Mynydd Llanhilleth Wind Farm

Draft Environmental Statement

Appendix 14C JRC Assessment

WF Coordination - Further Analysis Engineering Notes

The Signal Paths and Cross-Section diagrams for Turbine 3 and link in the nominal positions are shown:

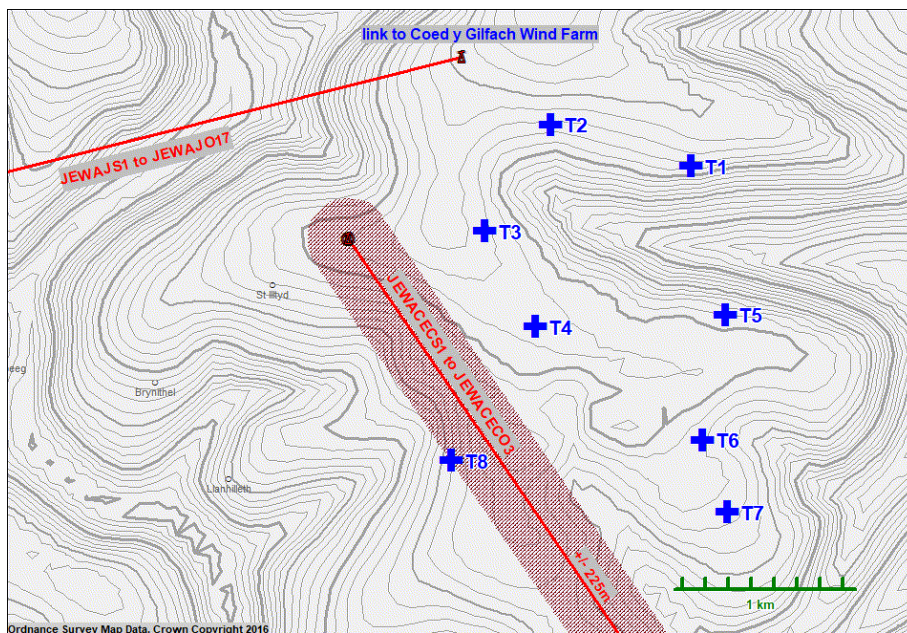
The signal path diagram shows the signal reflection criteria, where unacceptable interference could occur when the signal from the secondary path via the Wind Turbine is large compared with the direct signal path.

In this instance, when taking into account terrain and clutter, the direct signal path is not significantly more obstructed than the signal path via Turbine 8, and despite the proximity of the turbine to the link, the ratio of wanted to potentially reflected signal is just acceptable.

Given that turbine T8 only just passes the reflection criteria, an exclusion region of +/- 225m has been defined around link JEWACECO3. The link path to the Coed y Gilfach Wind Farm is unaffected but shown for reference.

It is considered that, subject to turbines not entering the exclusion zone, the proposal could be accepted. The final decision on acceptance, would be with the link operators, National Grid Telecoms.
